ARC REVIEW CODE: R1712181

**TO:** Mayor A. Max Bacon, City of Smyrna  
**ATTN TO:** Ken Suddreth, Community Development Director  
**FROM:** Douglas R. Hooker, Executive Director, ARC  
**RE:** Development of Regional Impact (DRI) Review

**Name of Proposal:** Emerson Center (DRI 2764)

**EMERSON CENTER DRI**  
**City of Smyrna**  
**Natural Resources Group Review Comments**  
**December 13, 2017**

**DRI SITE PLAN**  
EMERSON CENTER  
LAND LOTS 880 & 881  
17th DISTRICT, 2nd SECTION  
COBB COUNTY GEORGIA

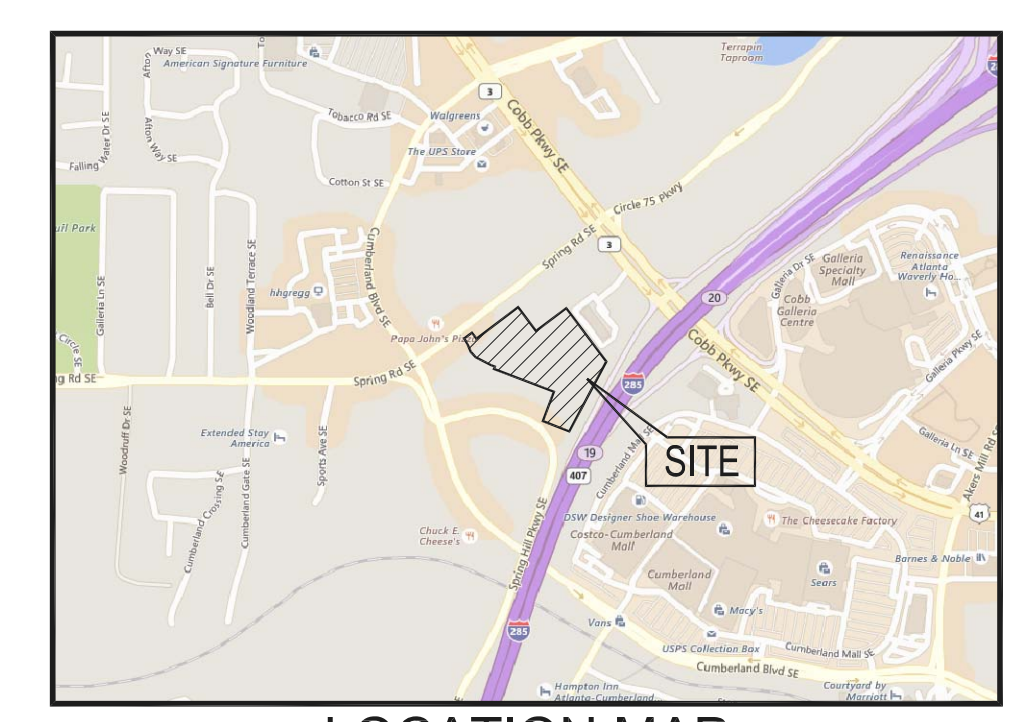
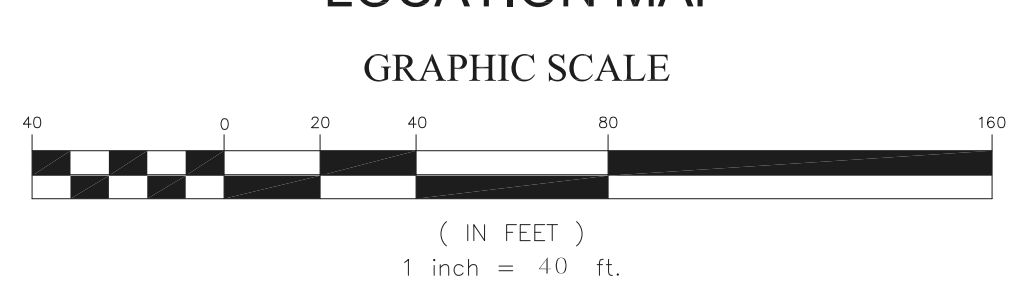
Along those lines, care should be taken to ensure that the development promotes a functional, safe, clearly marked and comfortable pedestrian experience on all streets, paths and parking areas. Especially given the opportunity for district-wide connectivity via the two pedestrian bridges indicated on the site plan, ARC recommends that the development team reconsider how best to accommodate north-south pedestrian circulation internal to the site. Sidewalk access appears to end just south of the hotel at the Road C entrance to the parking structure for the multifamily component. Sidewalks do not appear to connect

directly to either of the future aerial pedestrian walkways. The development team is also encouraged to ensure that end-of-trip facilities (bicycle racks, etc.) are provided for residents, workers and visitors at key locations throughout the site. The project could further support The Atlanta Region's Plan in general if it incorporated other aspects of regional policy, including green infrastructure and/or low-impact design (e.g., rain gardens, vegetated swales, etc.) as part of any improvements to streetscapes, driveways, parking areas, buildings, etc.

Pedestrian facilities are currently available along existing roadways allowing for safe accessibility. The site plan does not provide information regarding pedestrian and bicycle facilities.

The site plan does not provide specific information or depictions of bicycle and pedestrian facilities. While there are opportunities vis site design to provide connectivity to adjacent parcels, the site plan does not show any proposed connections.
